LAND AT ELMSBROOK, BICESTER: **PROPOSED RESIDENTIAL DEVELOPMENT**

Evidence of Eur Ing D M Mason MBA BSc(Hons) CEng MICE DipEM

Planning Inspectorate Ref.No. APP/C3105/W/23/3315849

Cherwell District Council Application No. 21/01630/OUT

Title:
2031 Base Traffic Flows (Total Vehicle)
AM Peak Hour

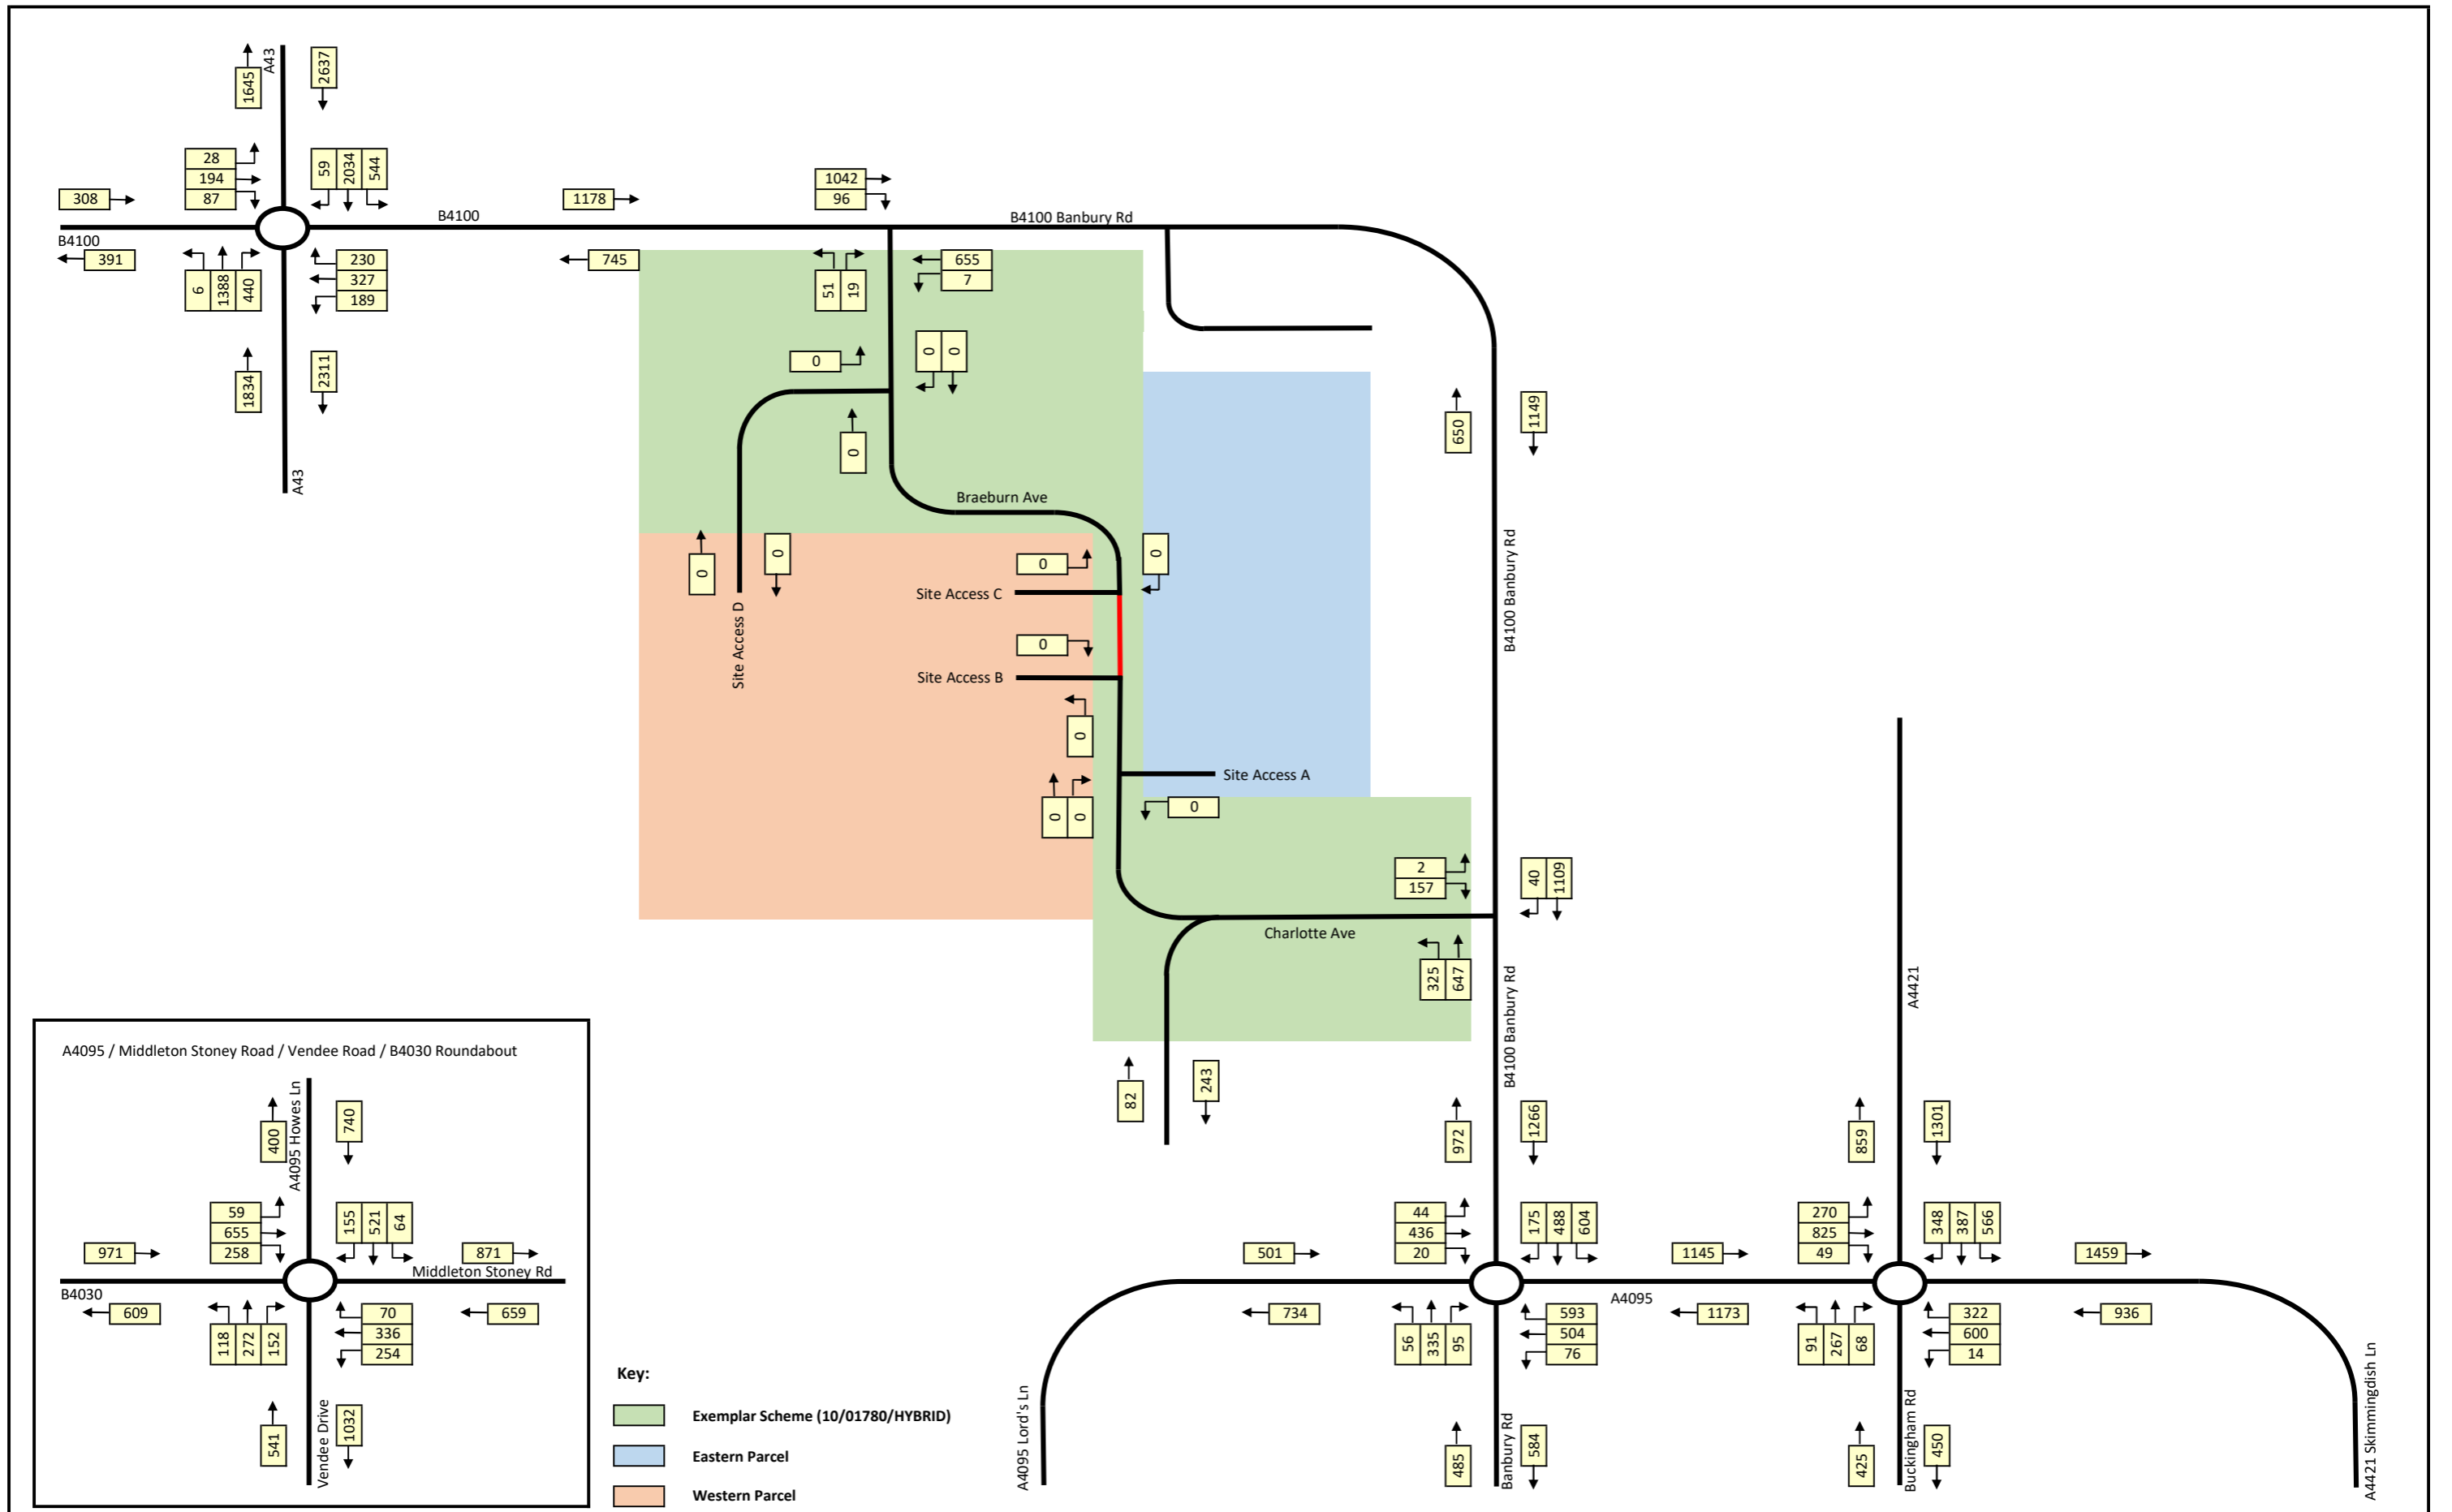
5.7 It is also notable that the model shows flows of 82 vehicles northbound and 243 vehicles southbound on Cranberry Avenue in the 2031 AM peak and 67 northbound and 119 southbound in the PM peak. Additionally, there are 325 vehicles turning left into Charlotte Avenue in the AM Peak. The development south of Cranberry Avenue is shown as residential on the NW Bicester Masterplan Framework.

5.8 These flows might be anticipated if the uses south of Charlotte Avenue served by Cranberry Avenue were employment uses. As noted above, they are not. The model appears to give highly unexpected traffic flows.

Appendix F Diagrams 8 and 9 from Transport Assessment by VTP,
2031 Base + Proposed Development Traffic Flows for the AM and PM Peaks.

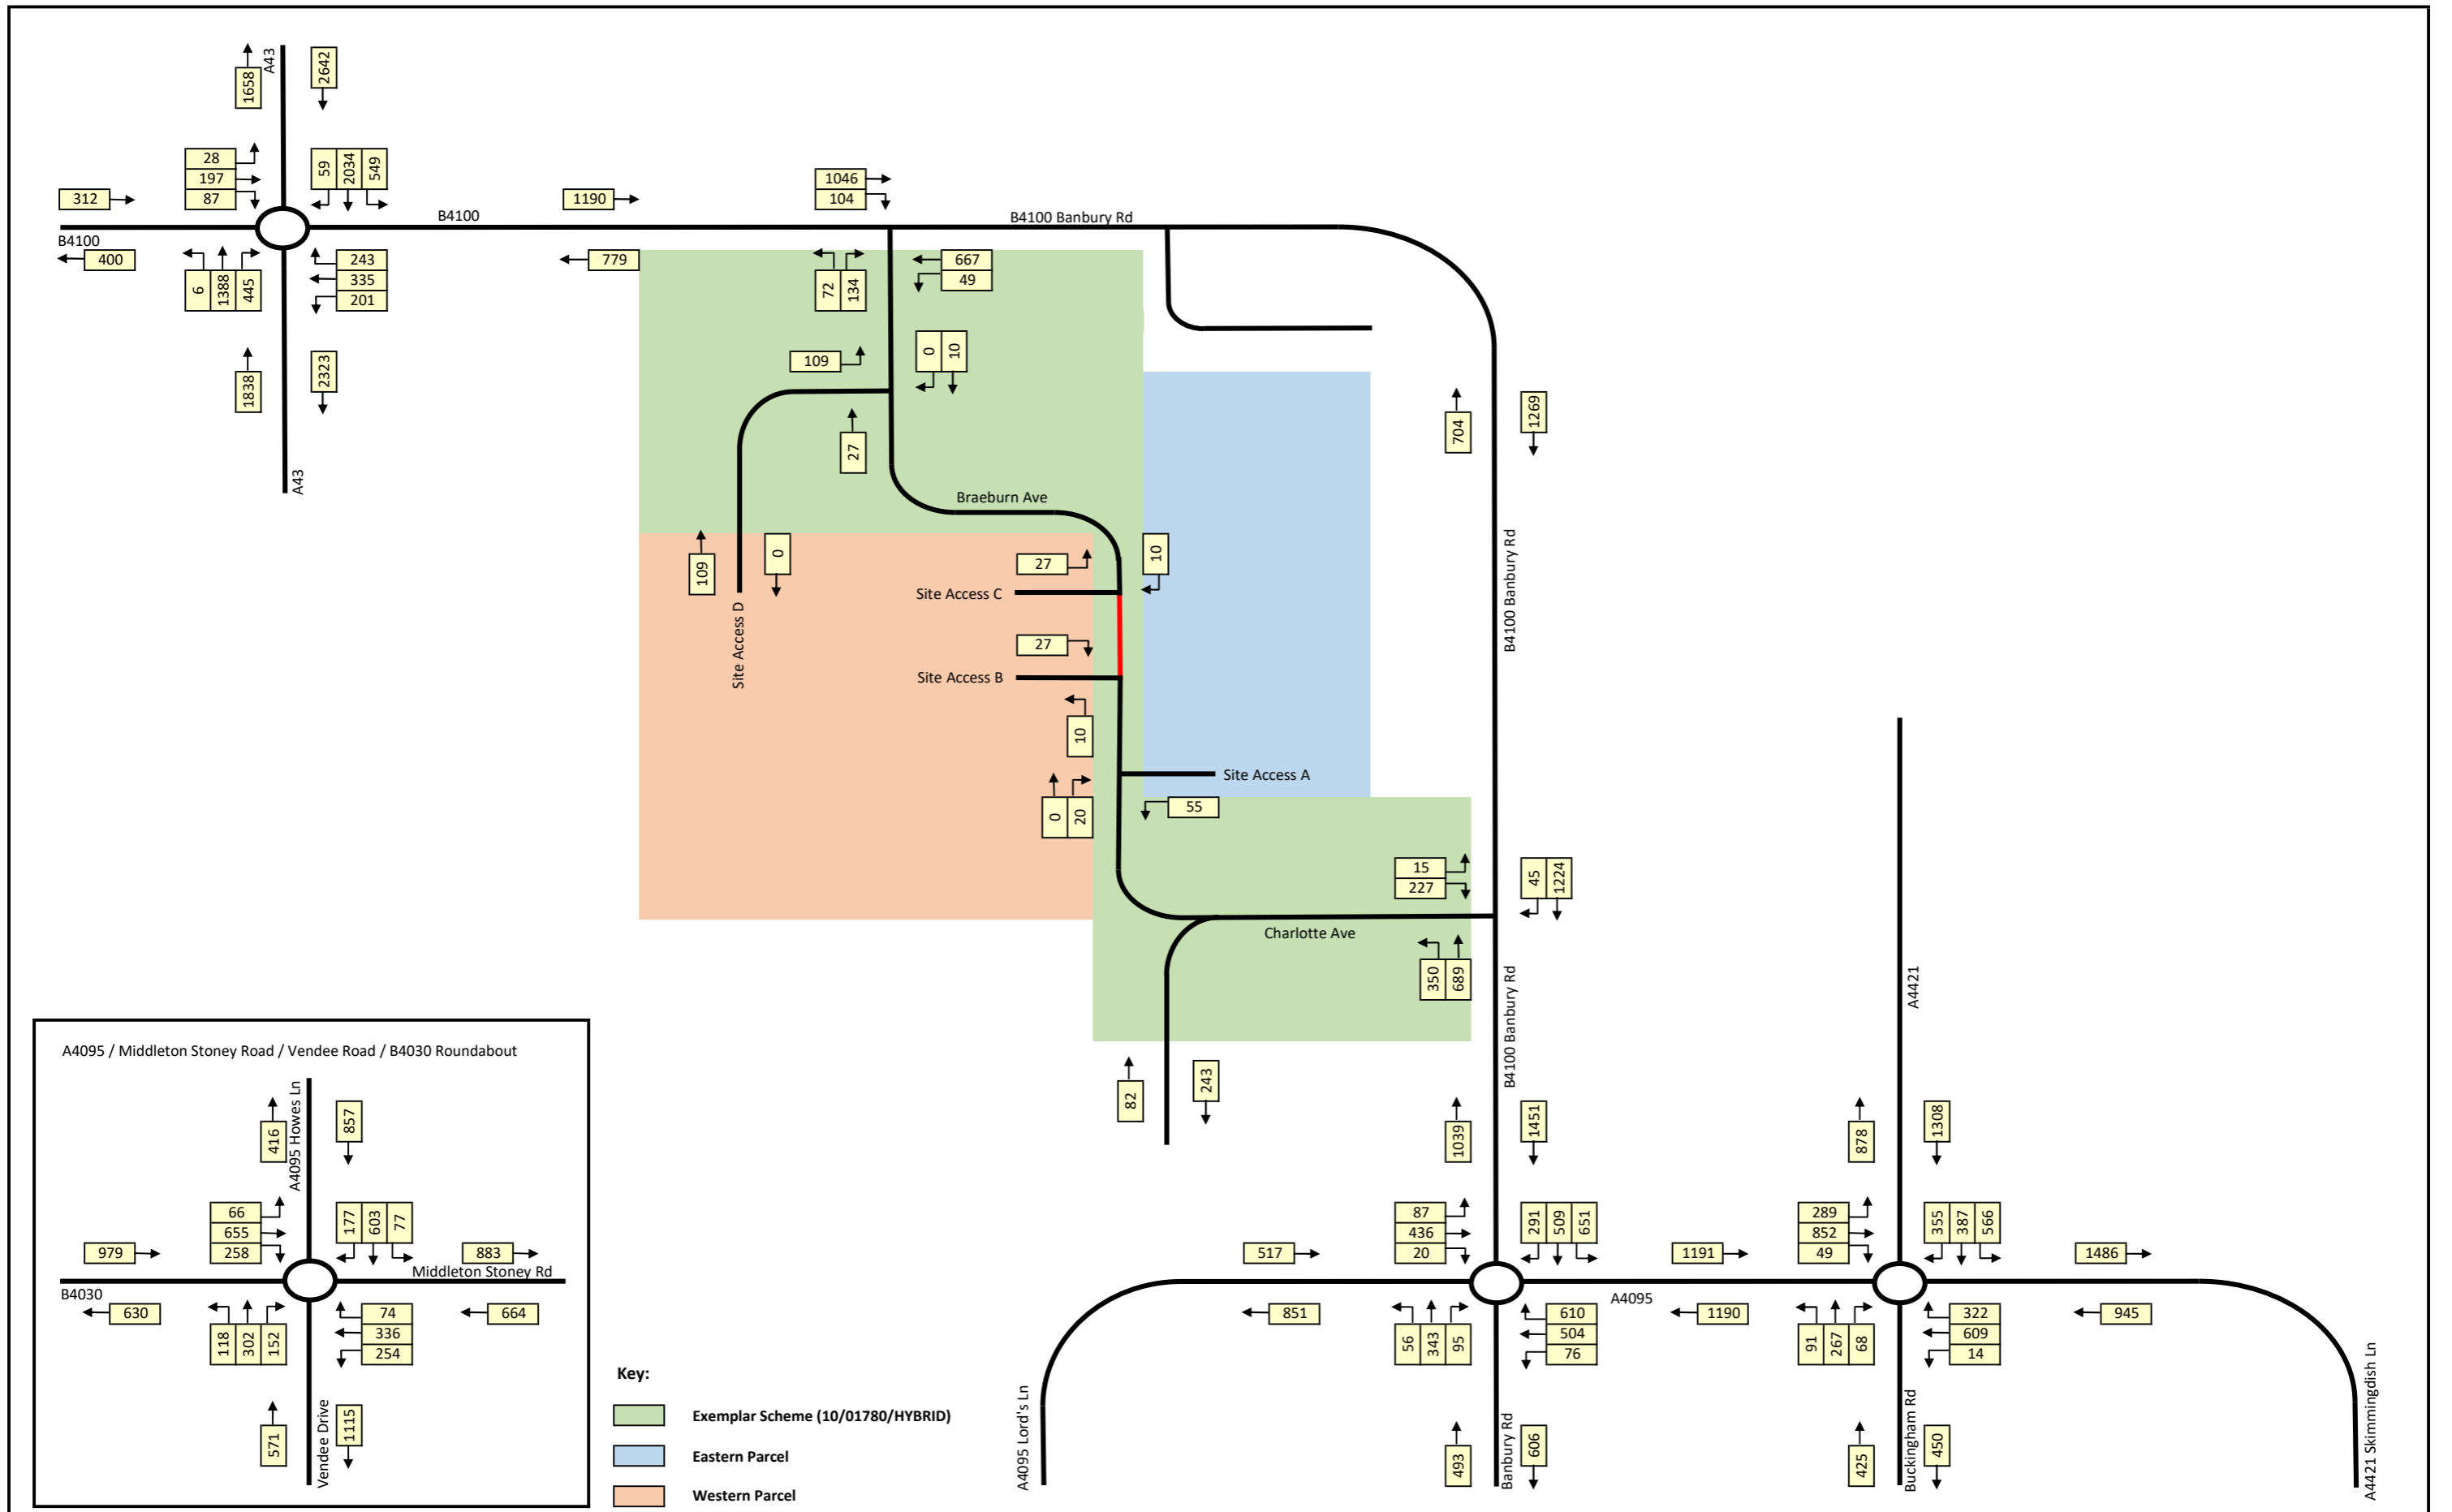
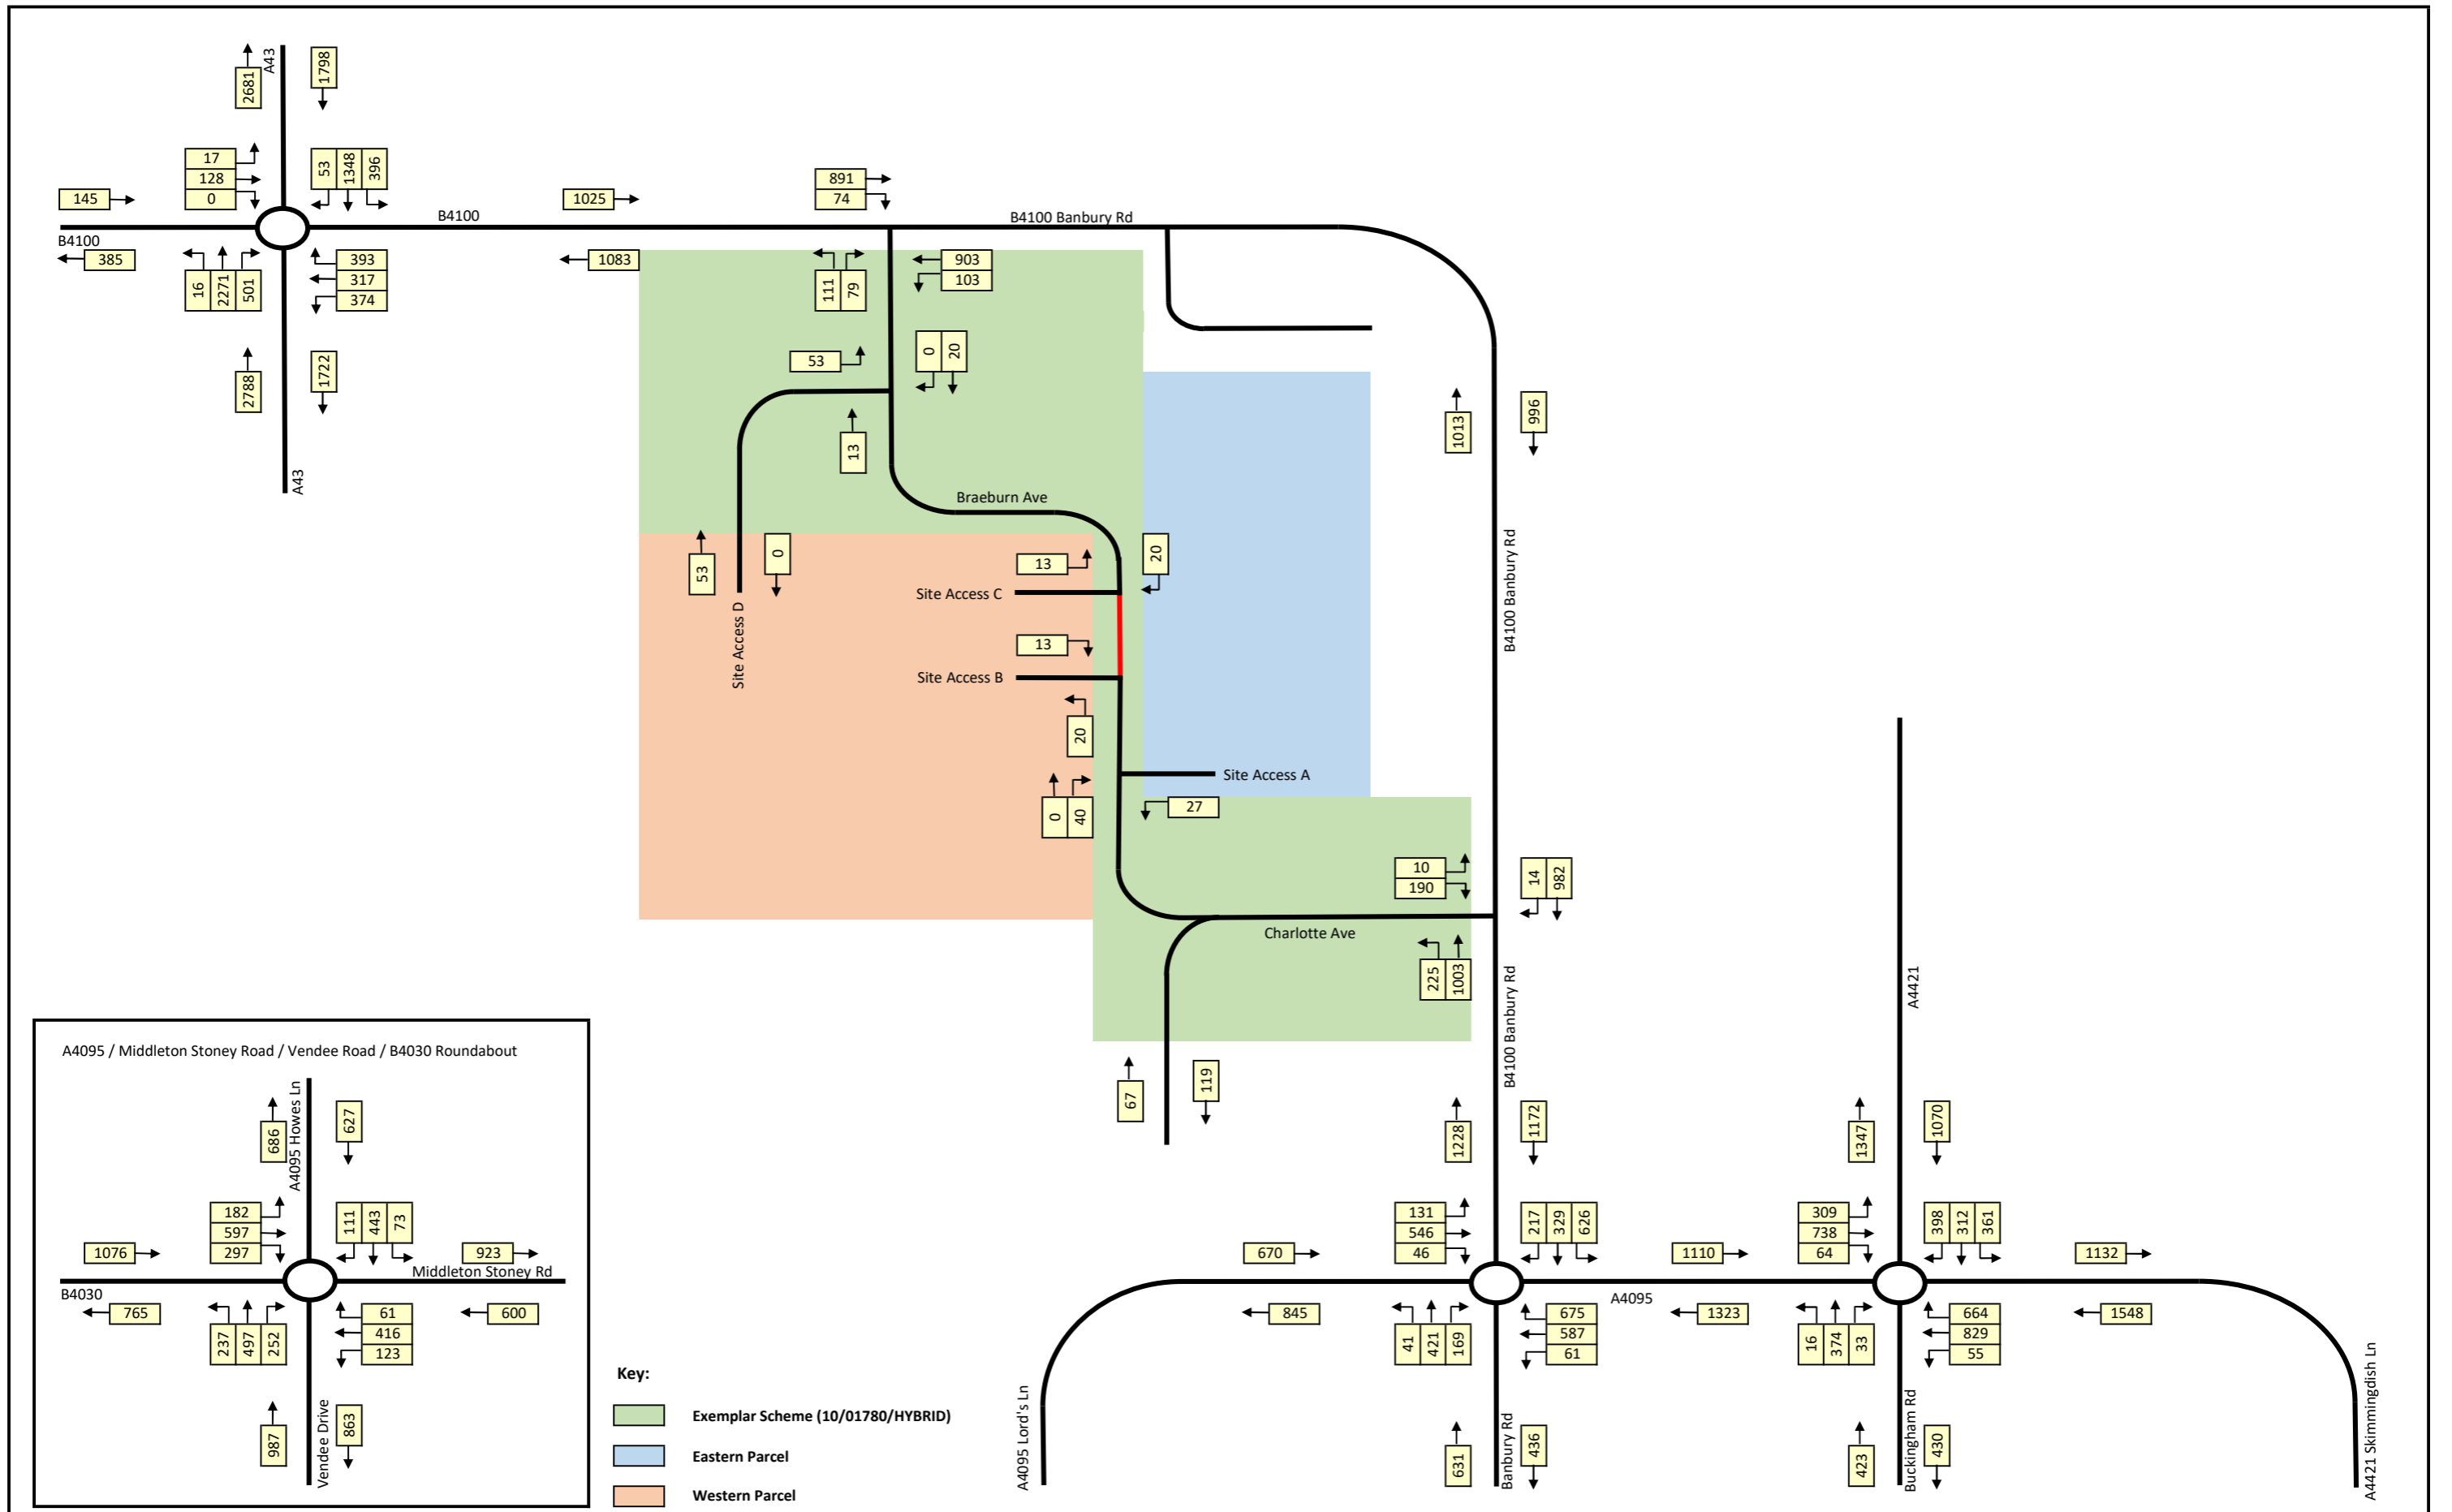
5.9 The Transport Assessment prepared by VTP gives traffic flow details in Appendix F. Diagrams 8 and 9 give 2031 Base + Proposed Development Traffic Flows for the AM and PM peaks respectively. The diagrams are reproduced at Appendix 3. It is noted that these traffic flows reflect the 40% trip generation by car modelling discussed in Section 4 above.
